Interoffice Memorandum

SUBJ: **Removal of "No Parking" signs on Lake Abbots Drive**

LAKEVIEW POINTE AT HORIZON WEST PHASE 2B

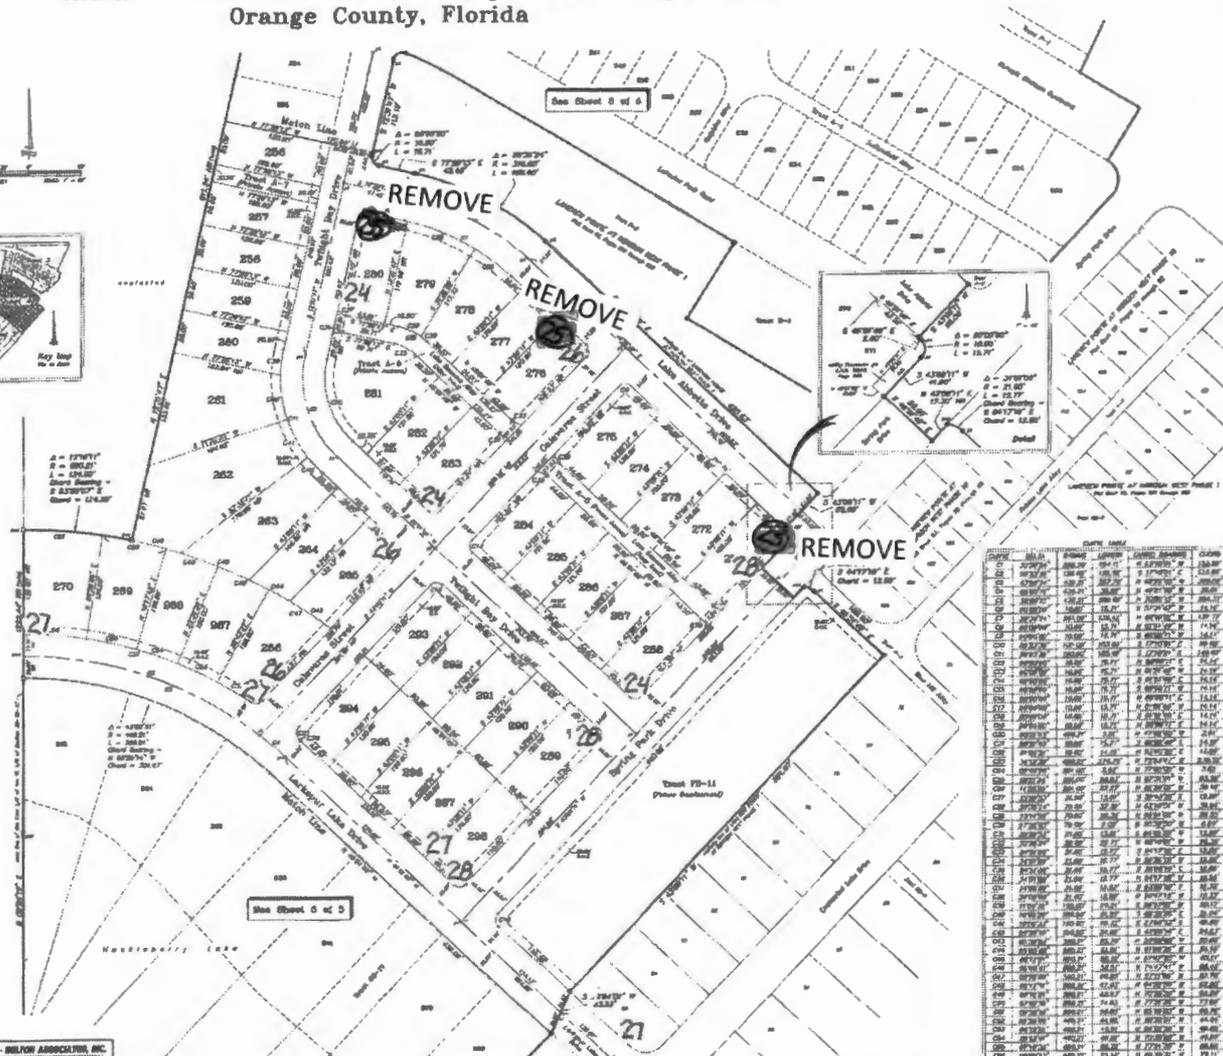
A citizen that resides on Lake Abbots Drive contacted Traffic Engineering to request removal of "No Parking" signs on Lake Abbots Drive from Twilight Bay Drive to Spring Park Drive.

Traffic Engineering staff reviewed the Traffic Control and No Parking plans approved by the Board in 2017 for the Lakeview Pointe at Horizon West Phase 2B subdivision and recommends removing the "No Parking" signs installed as part of these plans. The roadway width for Lake Abbots Drive is thirty-four feet wide and this roadway width is adequate to accommodate vehicles parked on both sides of the roadway with no obstructions for emergency vehicles.

Traffic Engineering has received concurrence from the Fire Marshal to remove the "No Parking" signs.

Action Requested: Approval to remove "No Parking" signs on Lake Abbots Drive from Twilight Bay Drive to Spring Park Drive. District 1.
